Model: K-C4	Date: 22-Jan-13	No.: RD158002a
-------------	-----------------	----------------

Subject: Firmware Release Note: PowerSaving Sys		Prepared by: Y.Saitoh	
From: 2nd Tech Service Sect., MFP/Printer Tech Service Dept.			
Classification:	<input type="checkbox"/> Troubleshooting <input type="checkbox"/> Mechanical <input type="checkbox"/> Paper path <input type="checkbox"/> Product Safety	<input type="checkbox"/> Part information <input type="checkbox"/> Electrical <input type="checkbox"/> Transmit/receive <input checked="" type="checkbox"/> Other (Firmware)	<input type="checkbox"/> Action required <input type="checkbox"/> Service manual revision <input type="checkbox"/> Retrofit information <input checked="" type="checkbox"/> Tier 2

This RTB has been issued to announce the firmware release information for the **PowerSaving Sys.**

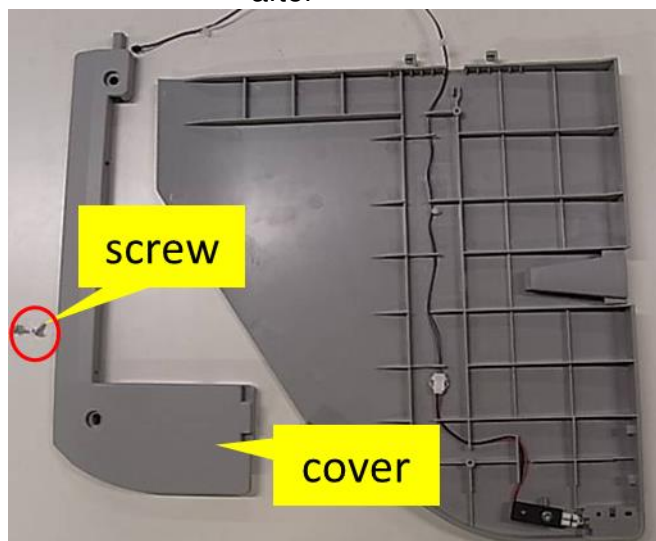
2. Remove the cover (screws x 2).

- after -

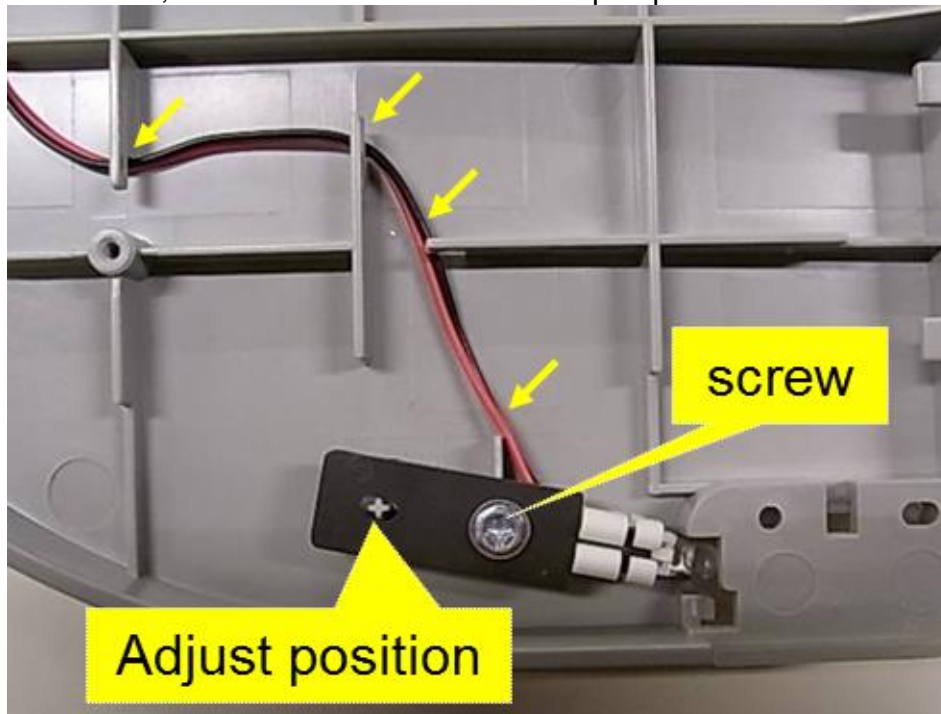
4. Re-route the harness as shown (avoid the path shown by the yellow dotted line).

5. Adjust the position of the convex part of the LED lamp inside the elliptical hole in the bracket, and then secure the LED lamp in place with the screw.

INCORRECT:

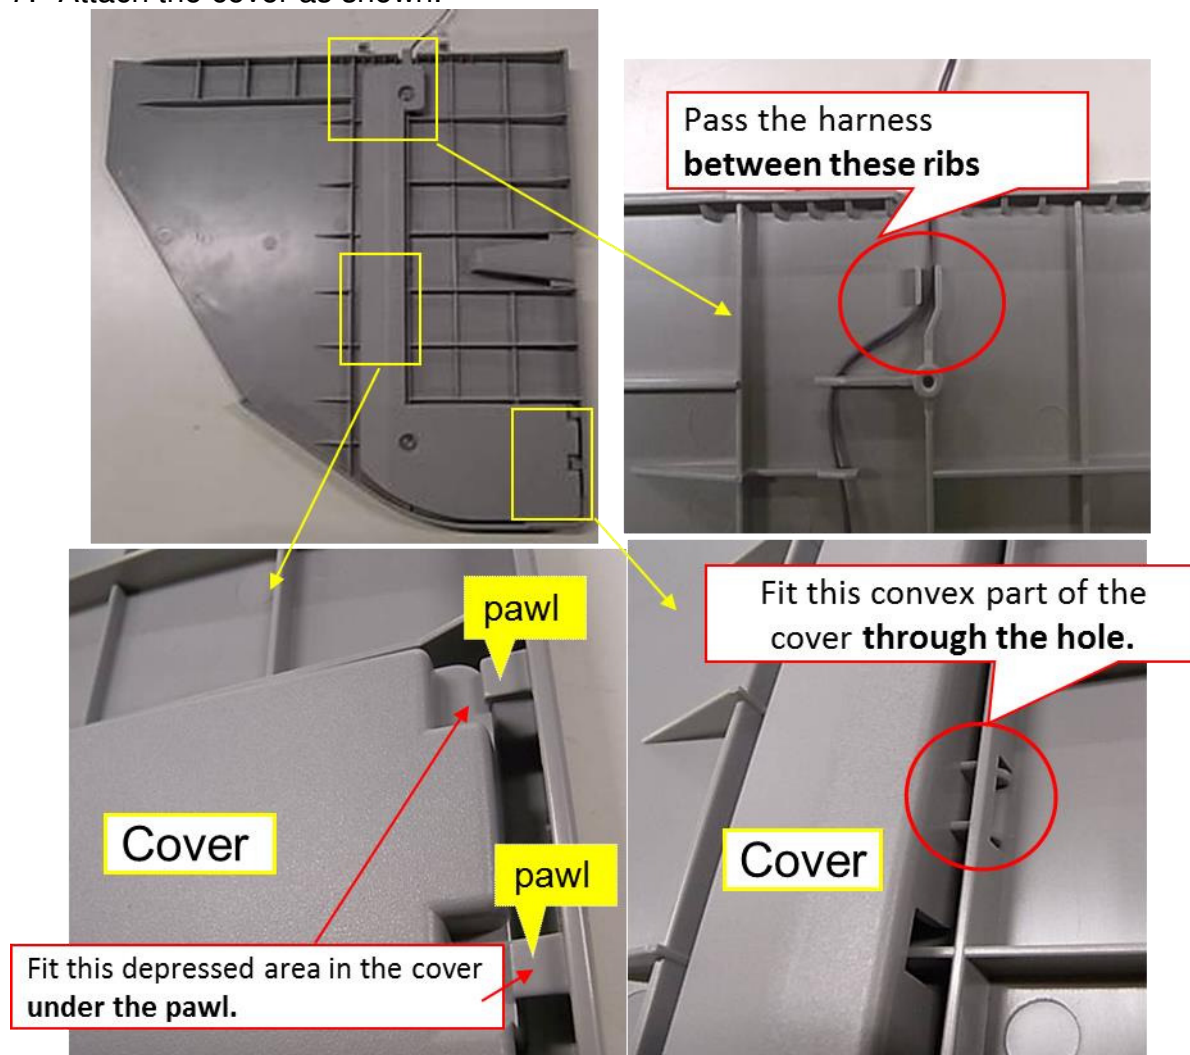
6. Re-route the harness as shown in the following photos.

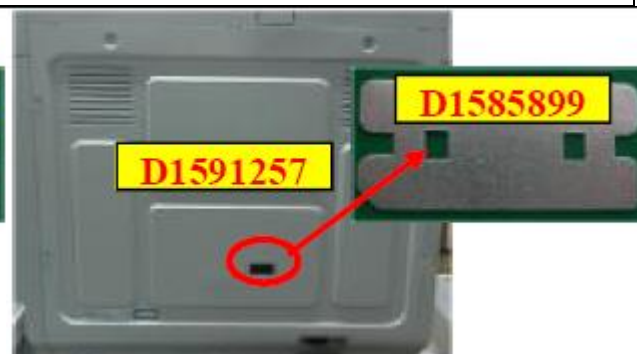
Reason: The material was changed.

Note: There is no difference in function between the old and new rear covers. The part number was changed for control purposes. Therefore, these parts do not have to be replaced as a set if the color difference is acceptable to the customer.
